## ADDENDUM #1

November 17, 2021

This Addendum to the Bid Documents is issued to clarify, correct, and supplement the Drawings issued as "WOODBURN MUSEUM/THEATER RENOVATION PERMIT REVISION DRAWINGS" dated September 27, 2021. This addendum adds to, and where in conflict with, supersedes previously issued drawings and addenda. This Document is hereby made a part of the Contract Documents to the same extent as though it were originally included therein.

Woodburn Museum / Theater  
Renovation

Scale As indicated  
Date 11/16/2021  
Sheet No. **A700**

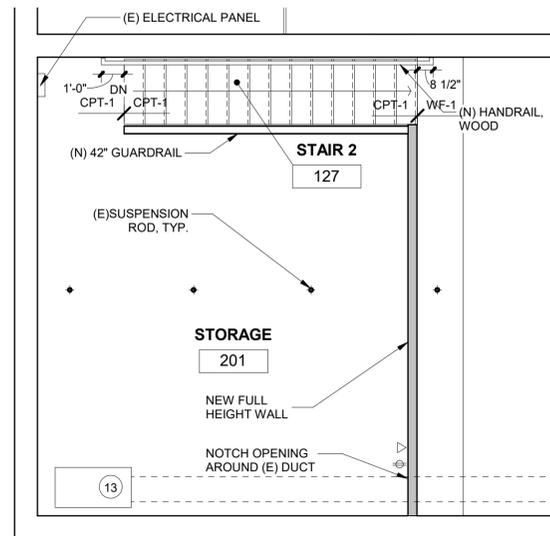
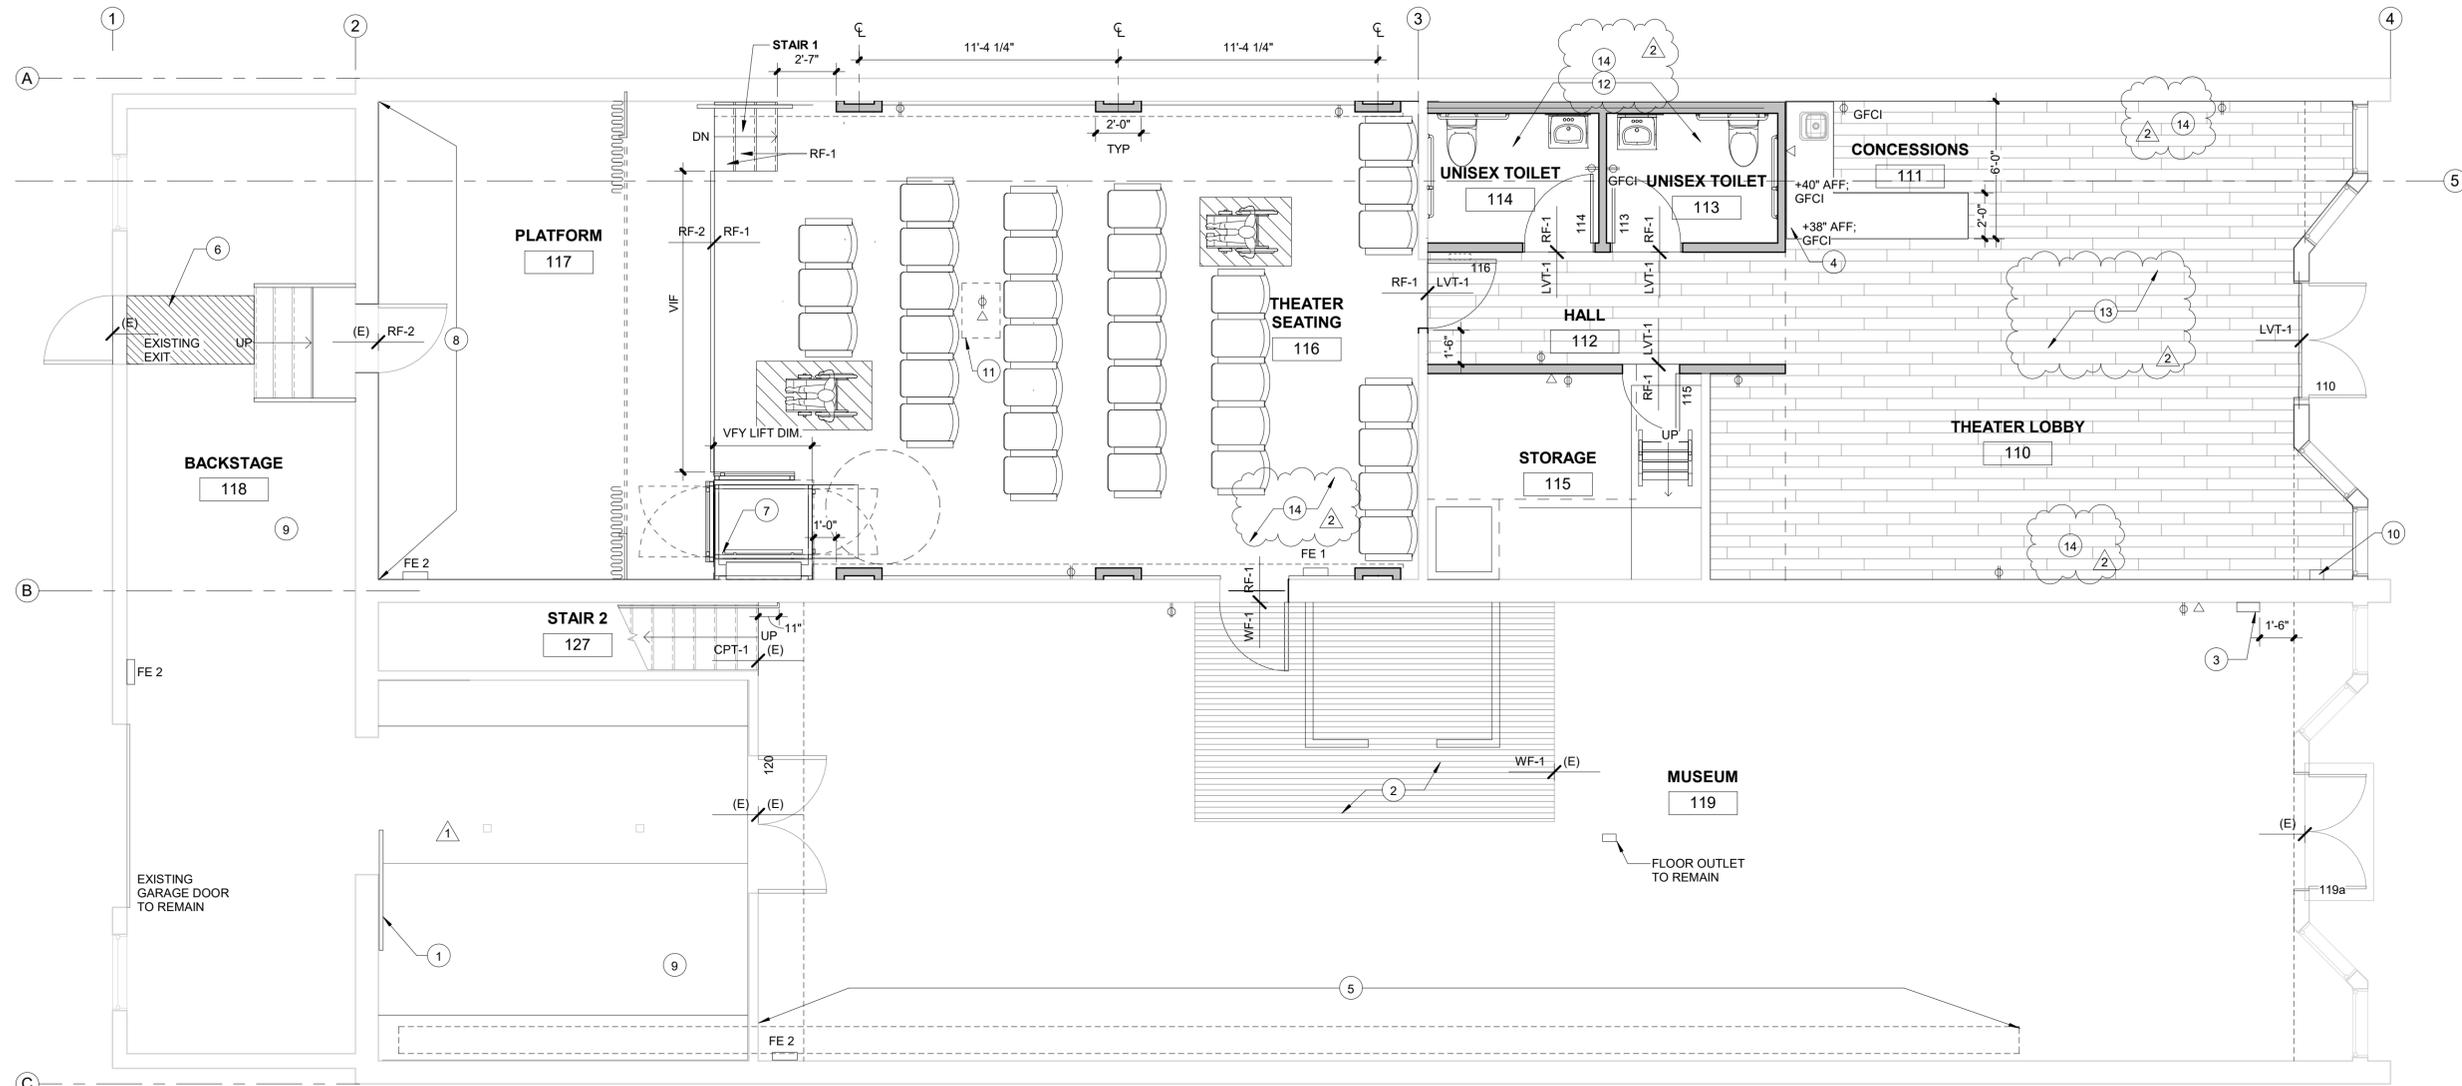
- 1.A603.1 2/A603 shows stage extension to accommodate clearances required for the lift.
- 1.A700.1 Theater Lobby 110: wall finishes – all walls should be skim coated to a smooth finish prior to paint. This will be added as a keynote and should be included in pricing.

- 1.A700.2 Throughout Theater: Provide new floor registers as required; keynote added.

- ALL WALLS TO RECEIVE A SKIM COAT FOR A SMOOTH SURFACE.
- PROVIDE NEW FLOOR REGISTERS AS NEEDED.
